TULSA METROPOLITAN AREA PLANNING COMMISSION

Meeting No. 2628

June 20, 2012, 1:30 PM

Building 3
2202 S. Ulca Place
Tulsa, Oklahoma

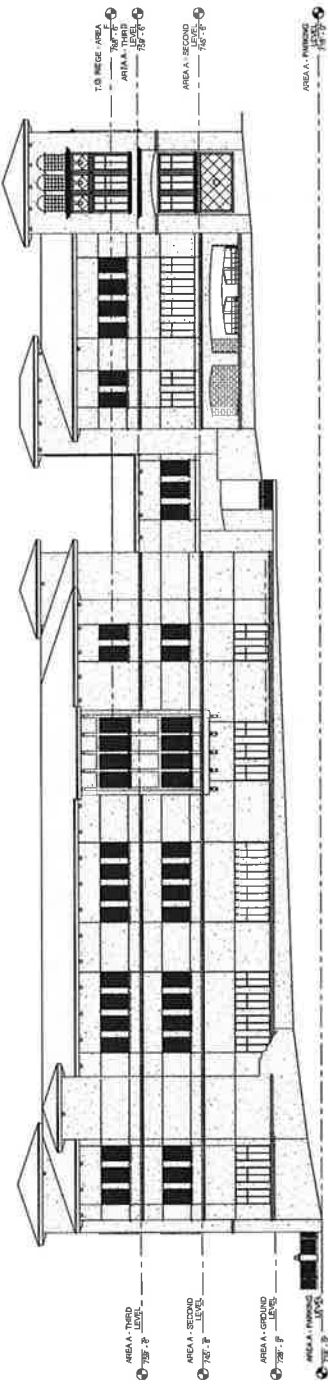
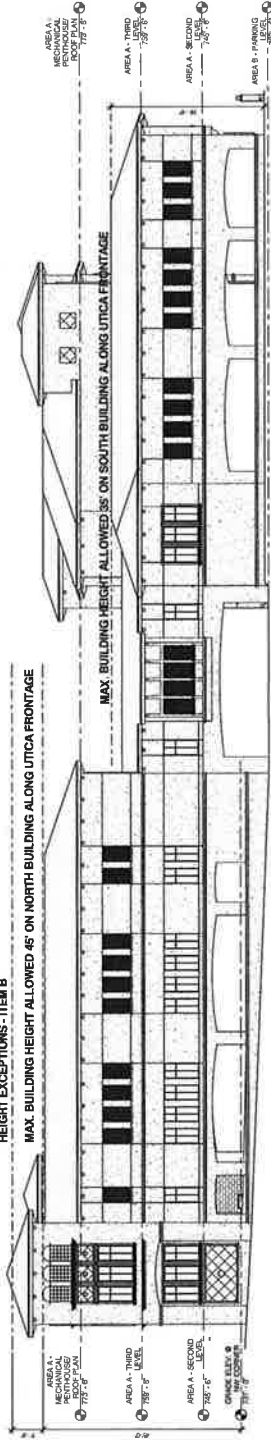
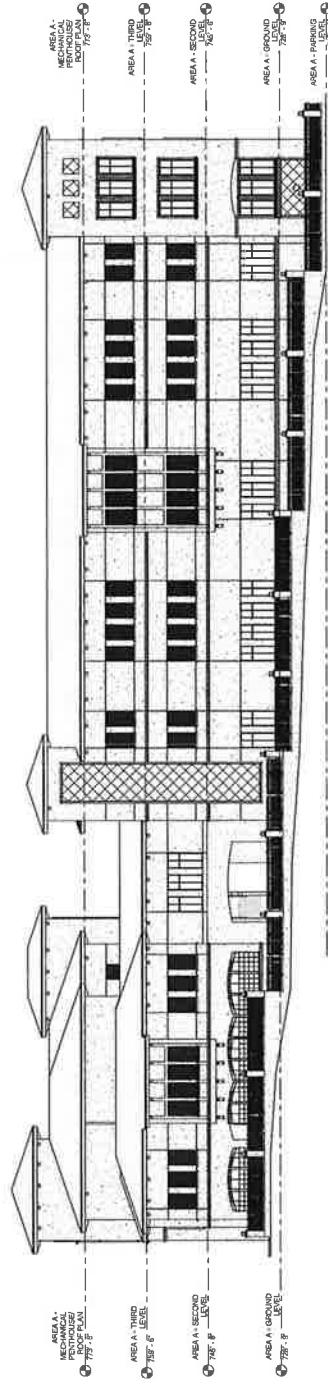
The submitted site plan meets all applicable, open space, building height and setback limitations. Please notice that the mechanical penthouse is above the 45' height limitation facing Utica and noted in the PUD however this area is a non occupied space and architectural element which is an allowed exception to the maximum building height as defined by section 208 of the Tulsa Zoning Code.

A SUBDIVISION OF PART OF
GOVERNMENT LOT 3 OF SECTION 18, T-18-N, R-14-E
CITY OF TULSA, TULSA COUNTY, OKLAHOMA
Planned Unit Development Number 559
Corridor District Site Plan Number 5888-SP-1

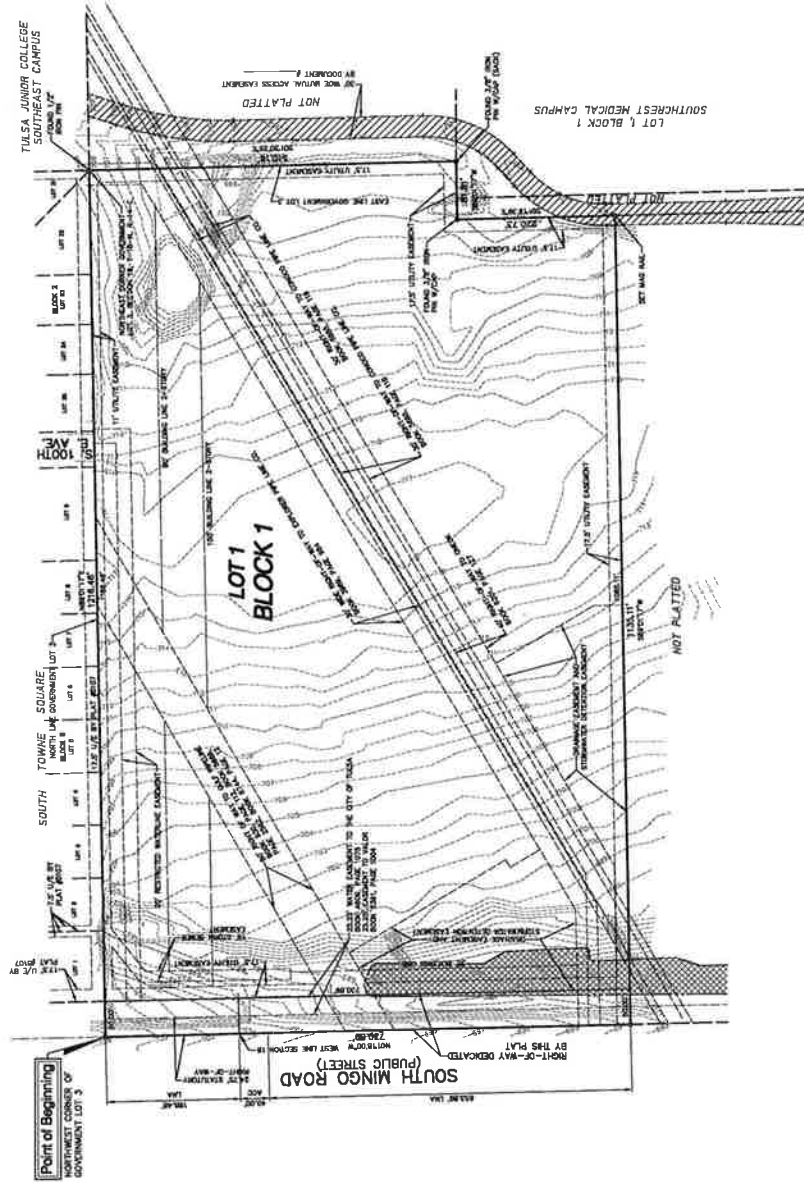
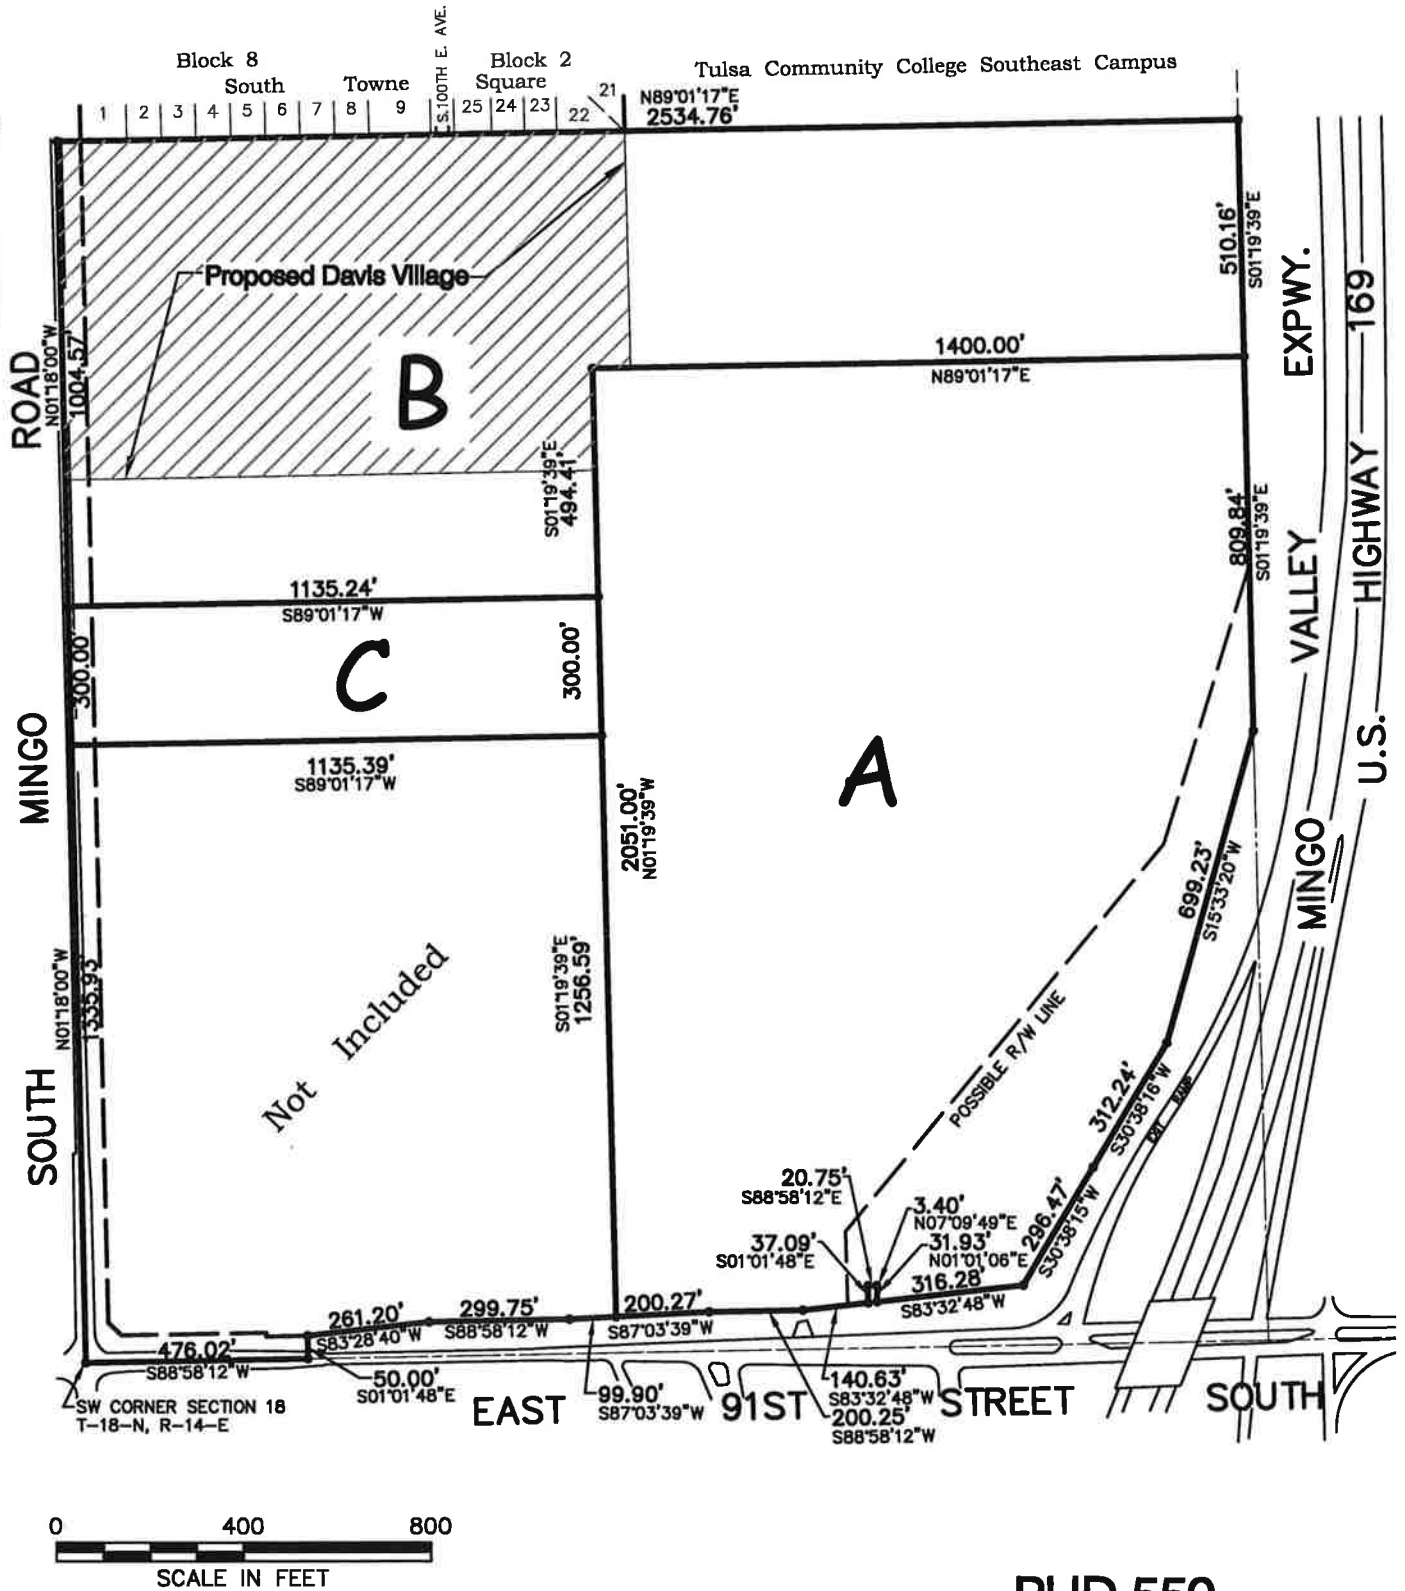
1. **Zoning:** The property is zoned Planned Unit Development 559 and Corridor 5888-SP-1. Limits of Access need to be shown appropriately per Traffic Engineering approval. A cul-de-sac or hammerhead should be provided for the stub street that terminates in the apartment project if the street is not going to provide through access. Explorer pipeline has to release the plat and needs to determine if parking or crossing the existing line will be permitted. The "Gulf" pipeline at the northwest corner of the property has been sold to Verizon and this will need to have a release letter also. Show the full development area or areas over the plat on a separate sheet. The street to the east of the site is a private street and agreement to access the street needs to be shown from TCC and South Crest Hospital. There is no stub street or access to the property to the south. The original PUD conceptual plan showed an east/west street through the site. The consulting engineer needs to show why this could not be built as part of the proposal. Circulation is critical to the development. The Covenants need to be consistent with PUD and CO standards for the site. The existing trail, if crossed for access, would need approval through the Engineering Services Department especially as it was built with federal funding. After continuing the item for neighborhood concerns, the access along South Mingo Road has been shifted to the south.

2. **Streets:** No comment.
3. **Sewer:** Additional easement may be required to provide sanitary sewer service to the property. In Section I G, instead of "Installation or necessary maintenance" use "Constructing, Maintaining, Operating, Repairing, Replacing, and or Removing". You did not provide any information regarding sanitary sewer service to the proposed buildings. All 8 inch sewer lines, both public and private, must be constructed through the IDP (infrastructure development plan) process. Additional easement may be required for public sanitary sewer mains. No water connections will be approved until the sanitary sewer connections have been approved. The proposed finished floor elevation for building #14 does not appear to have enough fall to connect to the existing sanitary sewer main. The finished floor elevation for building # 4 also appears to be too low to allow a service line to connect.

5. **Storm Drainage:** Do not overlap detention easements, overland drainage easements, and storm sewer easements with each other. Please label the "Little Haikey Creek Tulsa Regulatory Floodplain" as such. The limits of the floodplain must be determined by plotting the master drainage plan profile elevations on a topography map with surveyed elevations. Please use City of Tulsa standard language for "Water, Sanitary Sewer, and Storm sewer service", "Surface Drainage" and "Roof Drain Requirements". In Section II: Please remove "Drainage Easement", and its language; and replace it with the City of Tulsa standard language for "Overland Drainage Easements".

7. **Other: Fire:** Provide fire hydrants per the International Fire code. Provide fire department aerial access if buildings exceed 30 feet in height. **GIS:** On the Location Map "Union Elementary No. 13 Addition" is not labeled. On the face of the plat state the scale of the drawing in written form underneath the graphic scale bar. Add the words "Preliminary Plat" above the plat name on the face of the plat. Submit a Subdivision Control Data Form per Subdivision Regulations. Add standard language for Certificate of Occupancy restrictions and utility easement dedication.
